REFERRAL AGENCY RESPONSE – (2511-49100 SDA)- RR2025/015/01

Operational works – removal, destruction or damage of marine plants (maintenance/ repairs to Saltwater Creek pedestrian bridge).

SALTWATER CREEK RAIL BRIDGE CONSERVATION

SECTION X
SCALE: 1 : 50

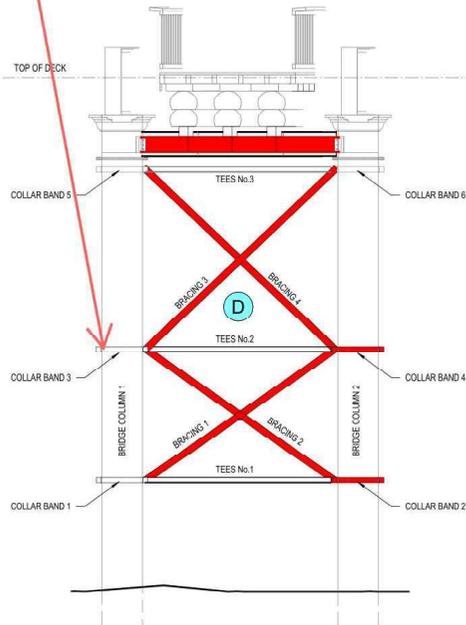
Collar band 1 and 3 to be highlighted red.

PIER 6 CROSS BEAM TOP PLATE REPLACEMENT - PART PLAN
SCALE: 1:20

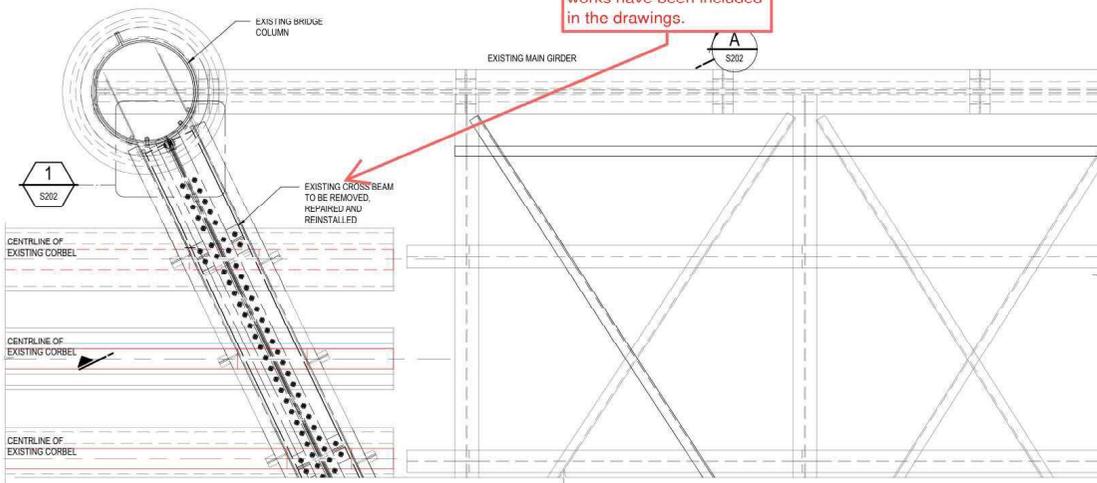
Is this a hangover from previous drawings or is removing and repair to existing cross beam an option? Noting no temp works have been included in the drawings.

DETAIL 1
SCALE 1:10
S203

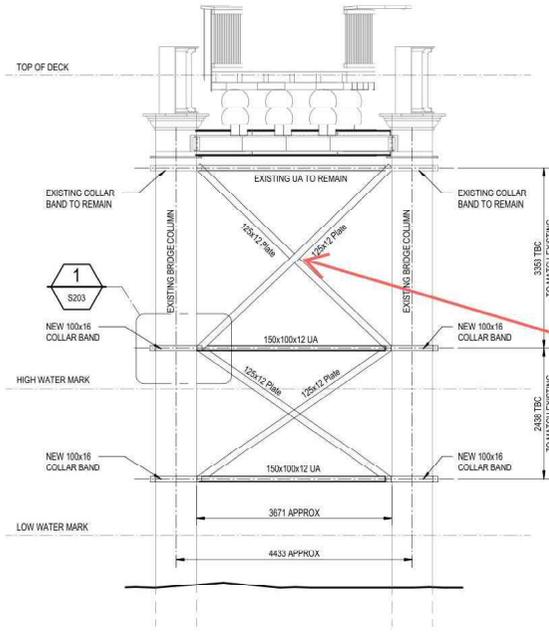
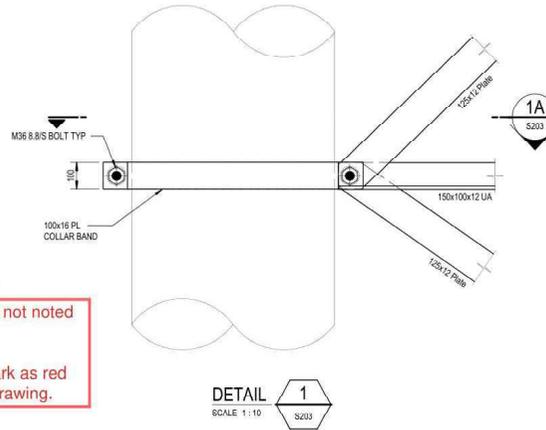
125x12 plates not noted as new.
Alternately mark as red as per S200 drawing.
